From: Franzone, Steve [<mailto:Steve.Franzone@fpl.com>]
Sent: Sunday, October 07, 2012 5:25 PM
To: Comar, Manny
Cc: Burski, Raymond; Maher, William; Franzone, Steve
Subject: DRAFT RAI Responses FPL Turkey Point 6 & 7 for eRAIs 6006 Stability of Subsurface Materials and Foundations

NRC RAI Letter No. PTN-RAI-LTR-040

SRP Section: 02.05.04 - Stability of Subsurface Materials and Foundations

NRC RAI Number: 02.05.04-6 (eRAI 6006)

Fig 2.5.4-203 Geotechnical Cross Section D-D' Through Unit 6 Power Block

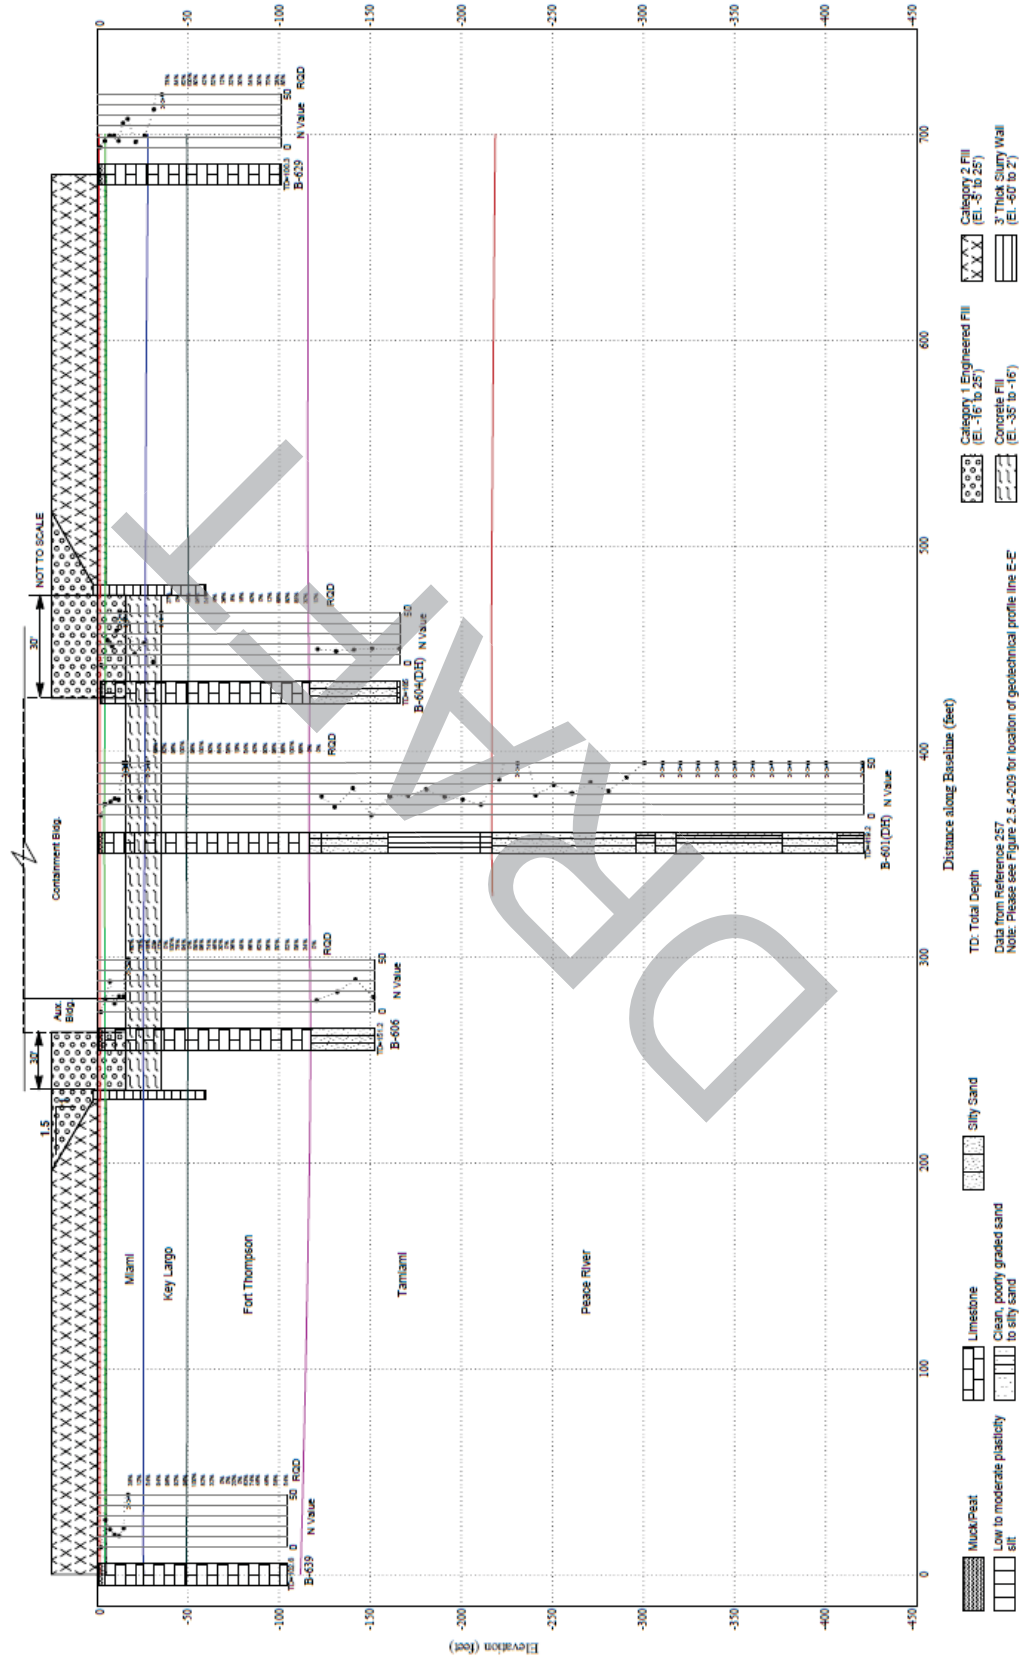
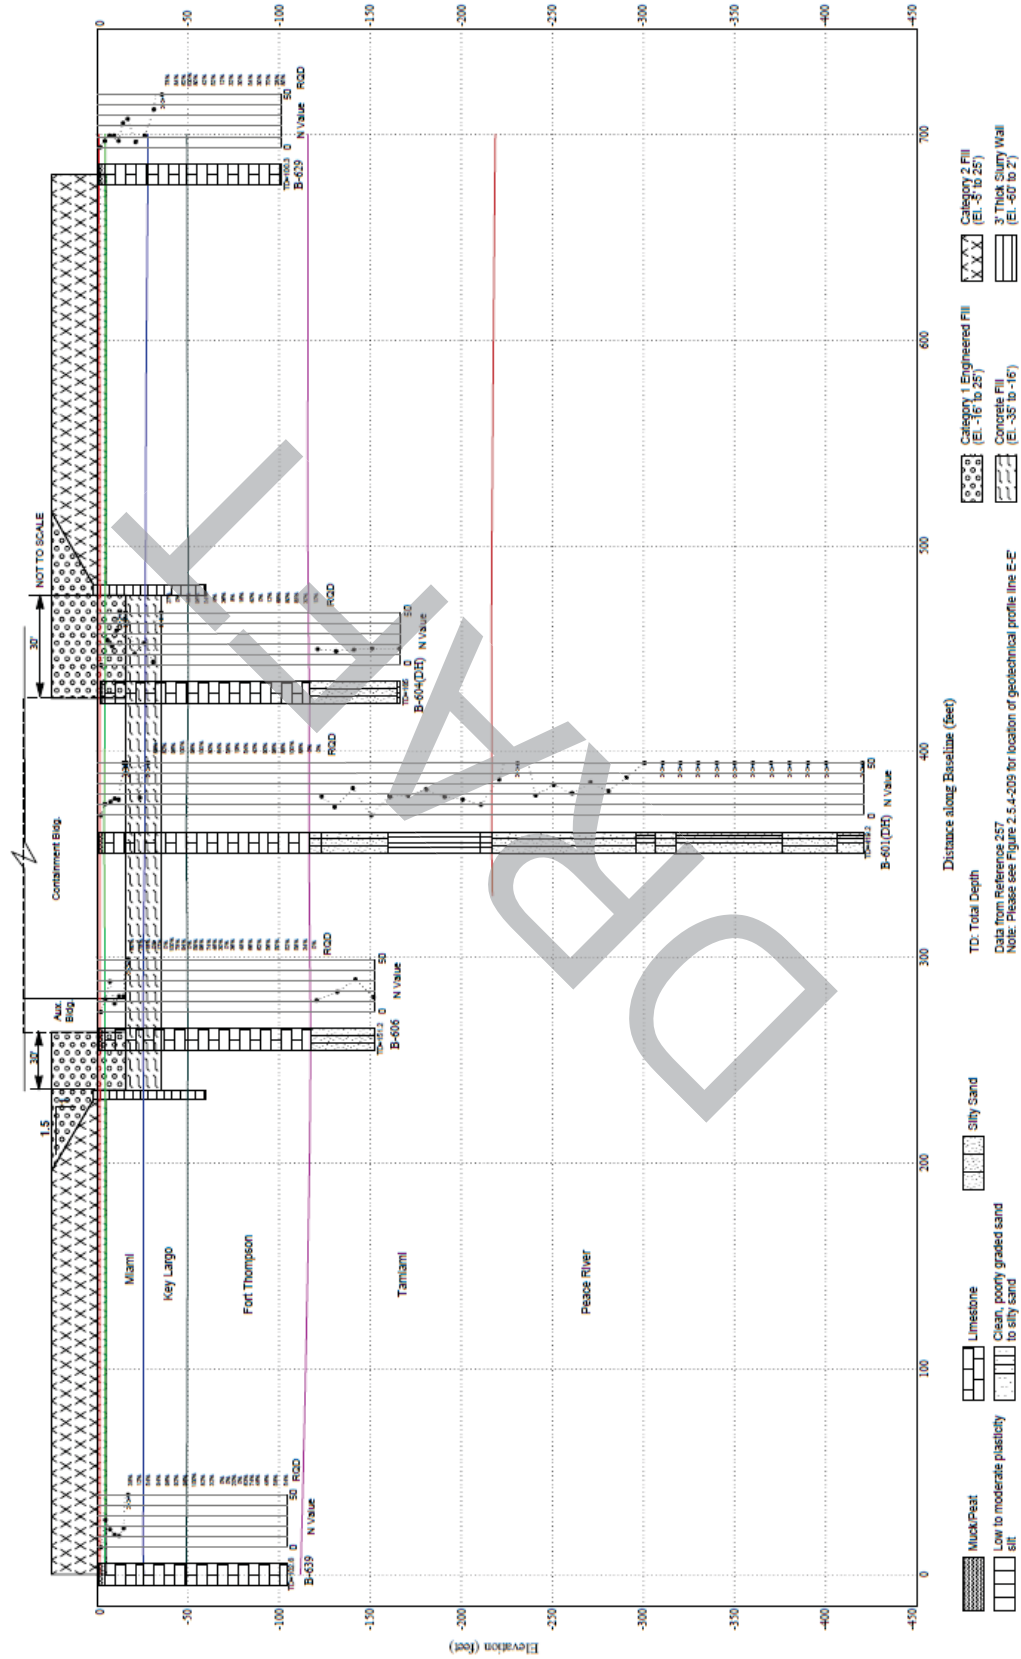
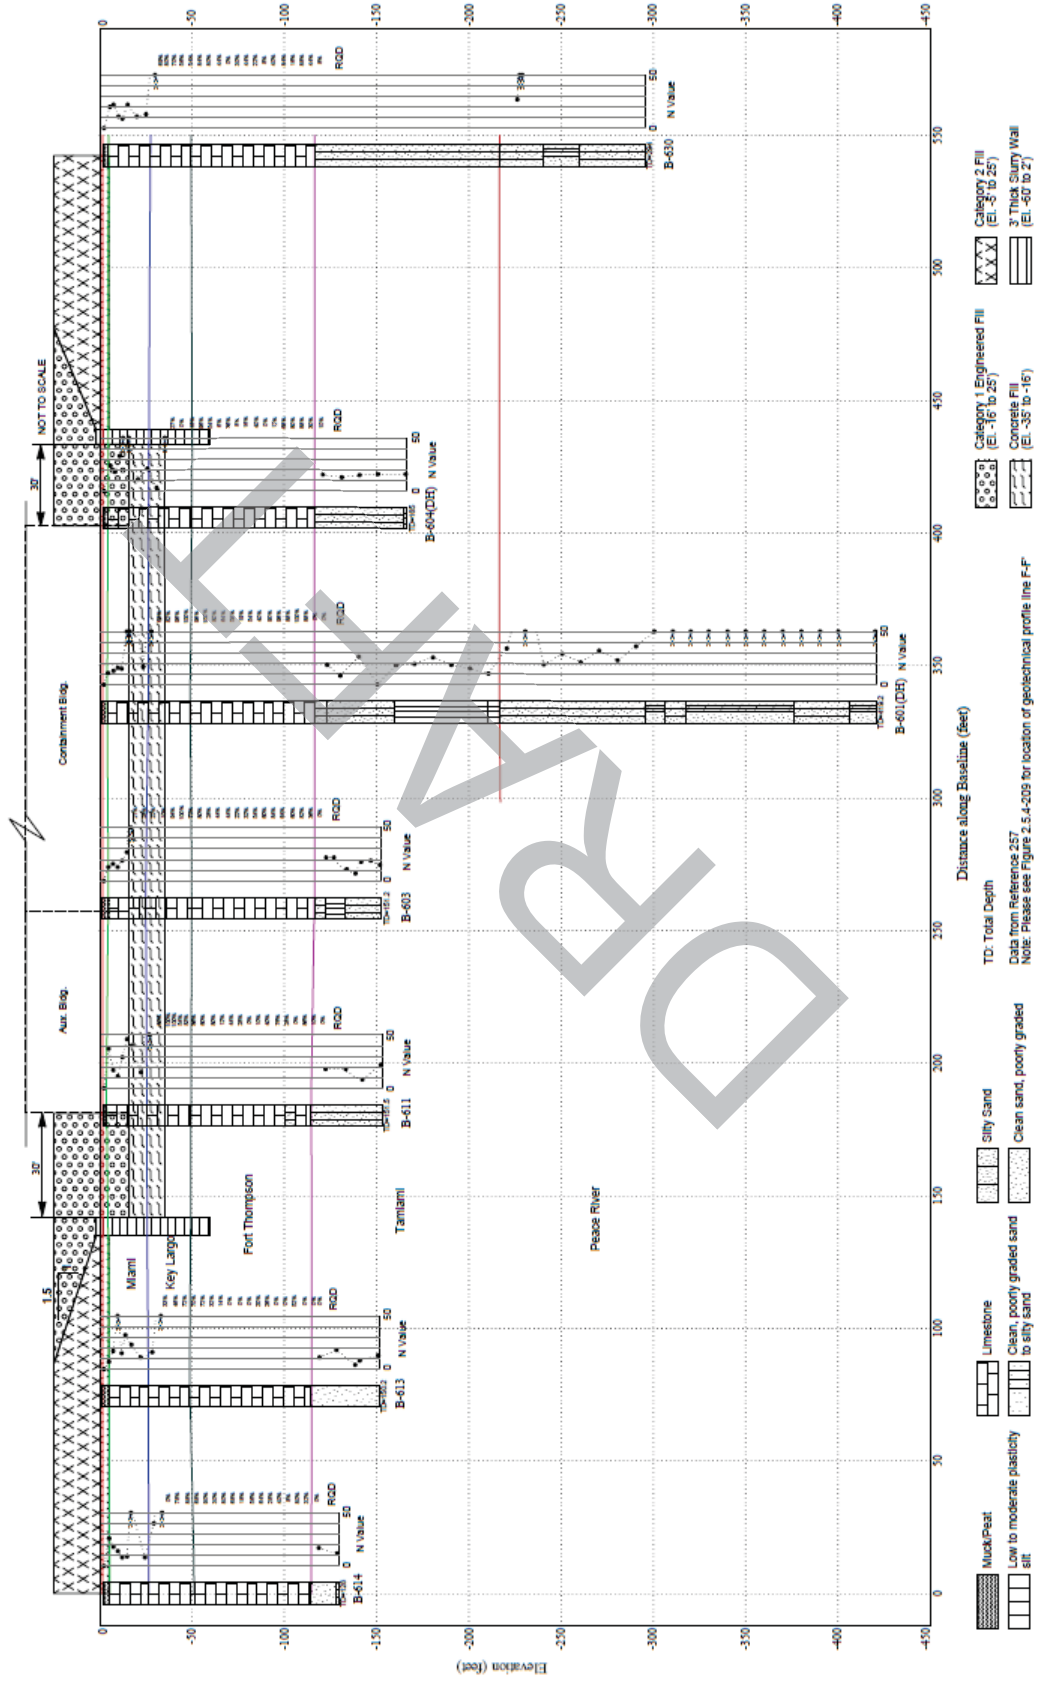
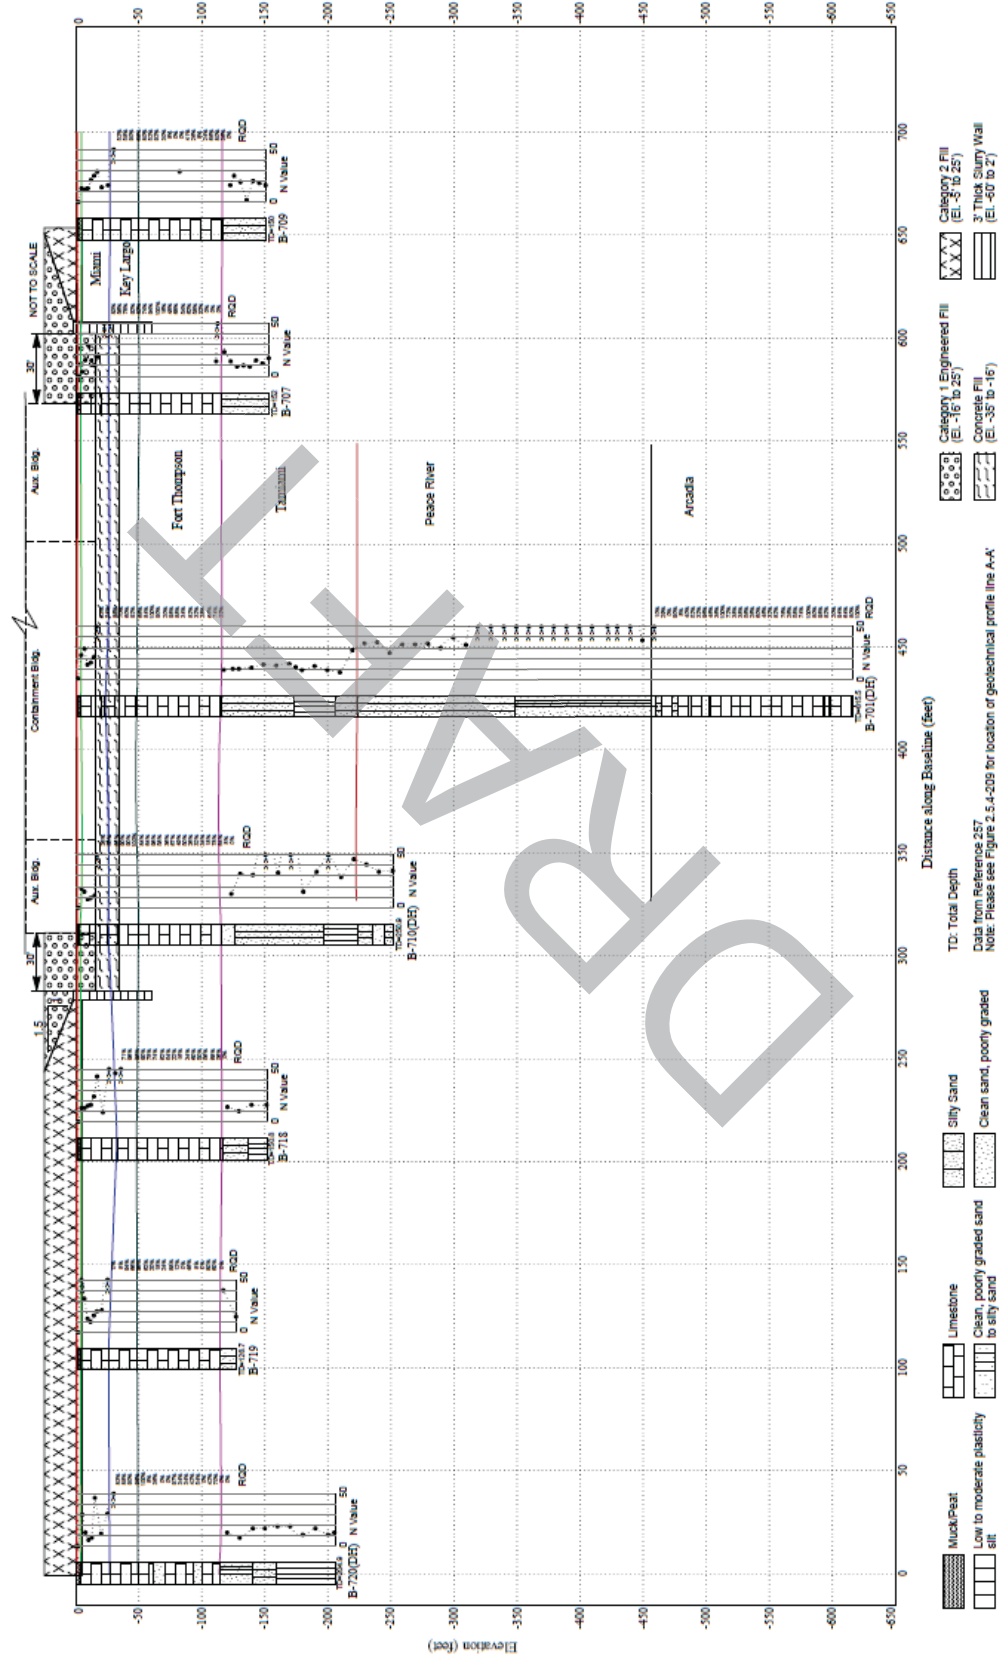
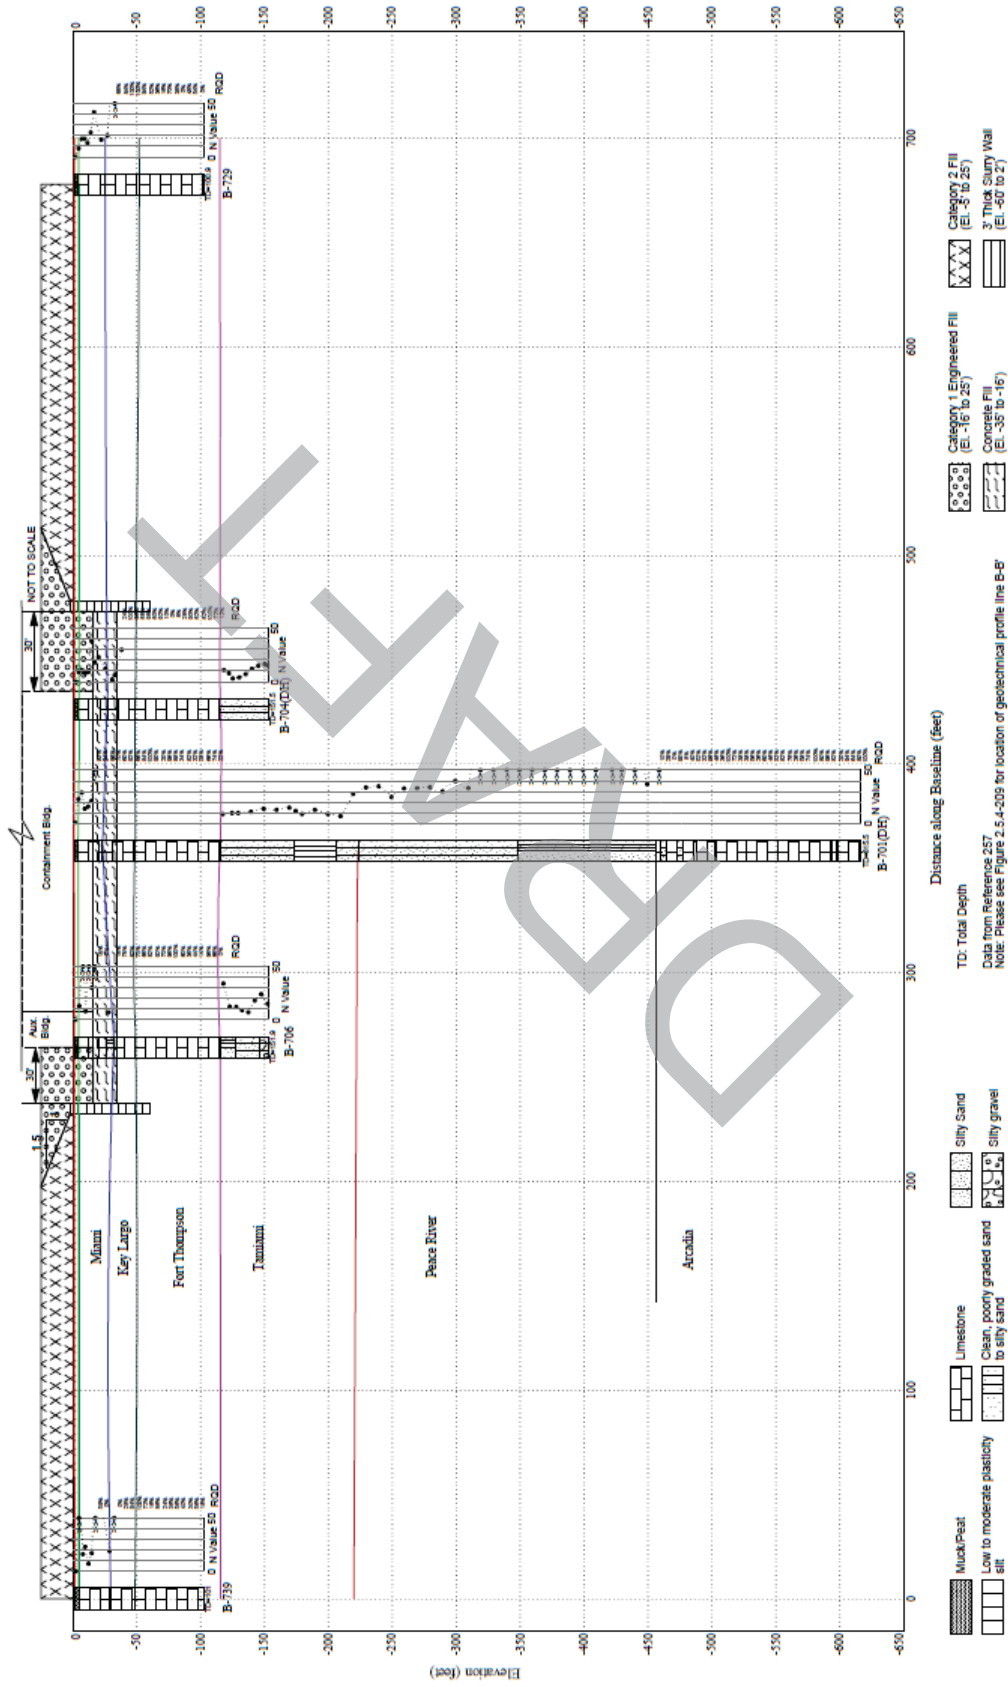
FSAR Figure 2.5.4-222 shows a general conceptual excavation cross-section. In accordance with NUREG-0800, Standard Review Plan, Chapter 2.5.4, "Stability of Subsurface Materials and Foundations," please describe the procedures that will be followed during site excavation and construction activity to ensure that the appropriate strata for the proposed foundation locations are confirmed through objective measures and the exposed foundation laying surface is uniform. Also, please provide the vertical and horizontal extent of all seismic categories I excavations, fills, and slopes, including the locations and limits of excavations, fills, and backfills on plot plans and geologic sections and profiles.

The profiles from the power block subsurface investigation (refer to FSAR Figures 2.5.4-203 through 2.5.4-208, copies of which are attached) show that the subsurface strata to support foundations are relatively horizontal. However, it should be noted that the extent of excavation to final subgrade and/or to final over-excavation level is determined during construction. This determination is based on observation and testing of actual subsurface materials encountered, and their suitability for foundation support.

Revised FSAR Figures 2.5.4-203 through 2.5.4-208 will be included in a future FSAR revision to show vertical and horizontal extent of excavations, fill locations and slopes. Note that dimensions and slopes on figures as shown are preliminary pending final design.
